ZONING AND PLATTING COMMISSION HILL COUNTRY ROADWAY SITE PLAN REVIEW SHEET

CASE NUMBER: SPC-2016-0453C ZAP COMMISSION DATE: January 16, 2018

PROJECT NAME: Westlake Residential

Westlake Residential Questions

SITE PLAN NOTES

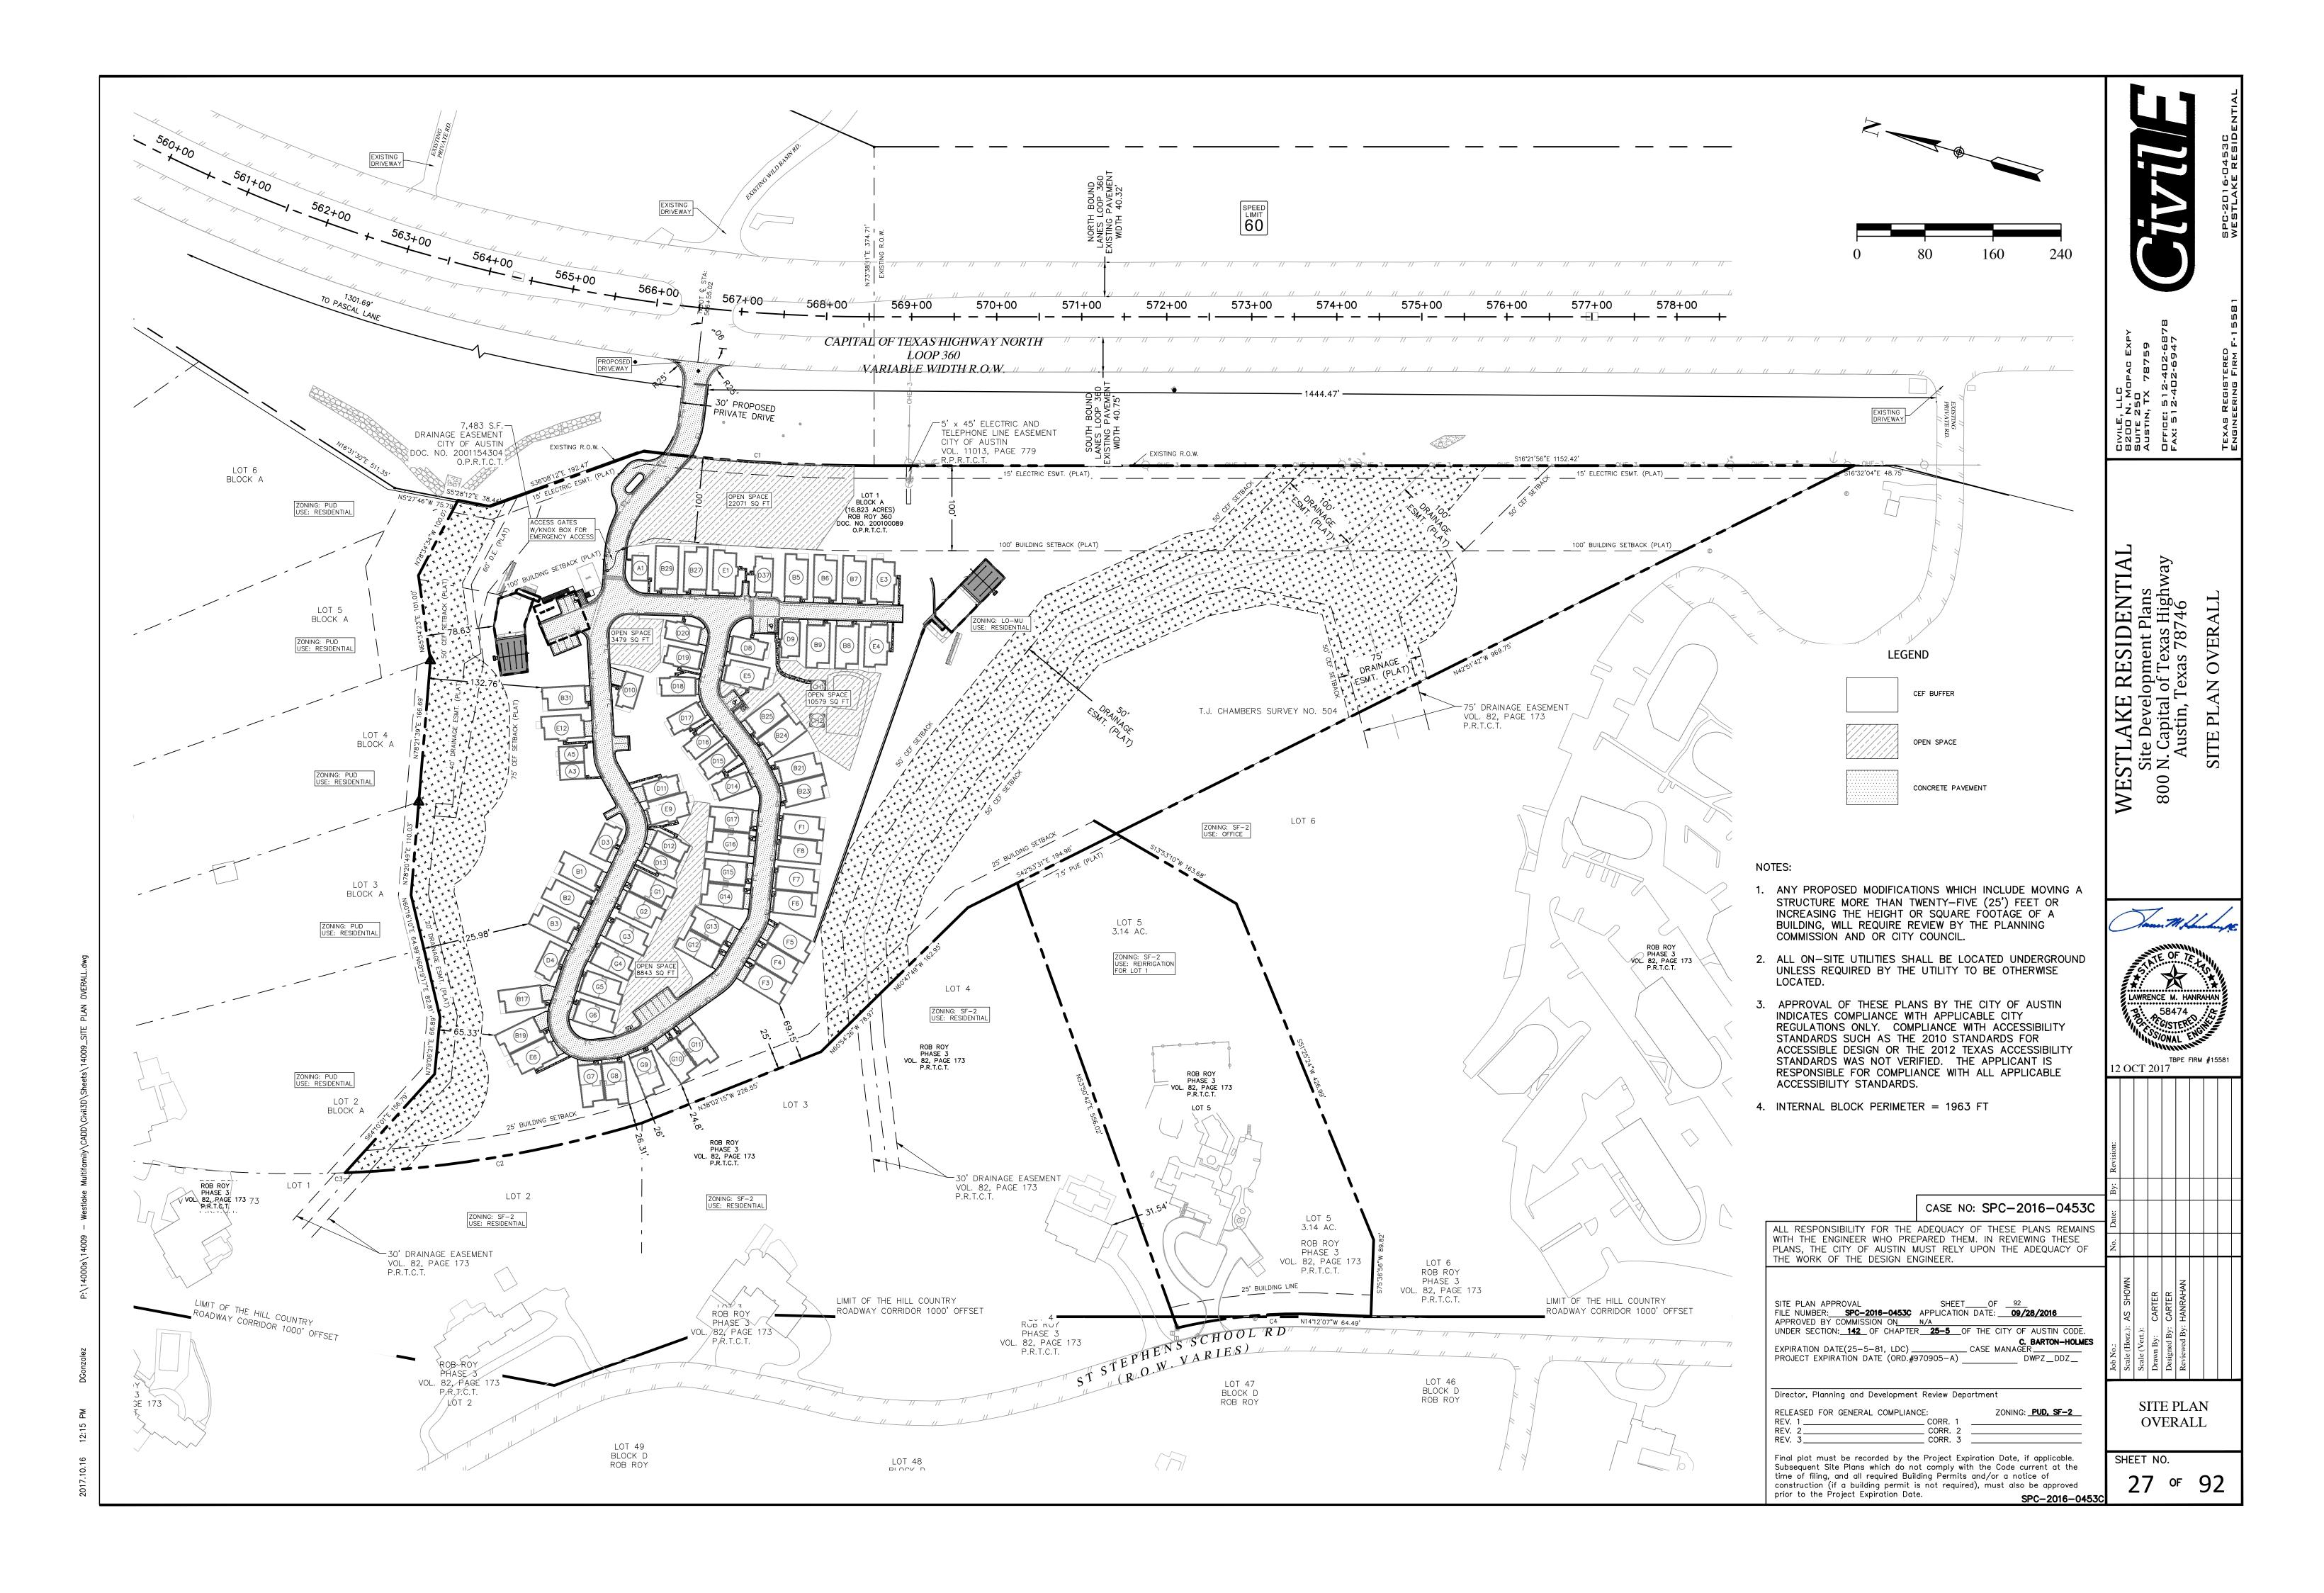
Commissioner King Questions

- 1. How many dwelling units are planned for the entire planned unit development (PUD) when it is fully built out? Applicant is researching. Current permitted acreage for residential is 243.89 acres, including all single-family, multifamily, and mixed use, out of 444.31 acres. This site is allowed 225 multifamily units per zoning; 67 units are proposed.

- 13. How will the wastewater irrigation impact the springs, wetland, and biological resource buffer on the site? In compliance with LDC 25-8-281 (C)(2)(a) No wastewater irrigation is proposed within the boundary of the CEF buffers. Outside the CEF buffers, there are proposed wastewater irrigation fields. Properly designed and maintained effluent irrigation fields should not result in overland effluent flow to the CEF buffers or the CEFs they protect (springs and wetlands). There is always a concern about potential shallow groundwater contribution of additional nutrients and salts moving towards the wetlands, springs and the creek that may potentially lead to degradation of these features. However, the project is compliant with defining the irrigation fields outside the boundaries of the CEF buffer.

- 26. Why is Lot 5 included in the project (2.3.1K)? Lot 5 is intended to serve as accessory to Lot 1, for treated wastewater irrigation. TCEQ is reviewing this.
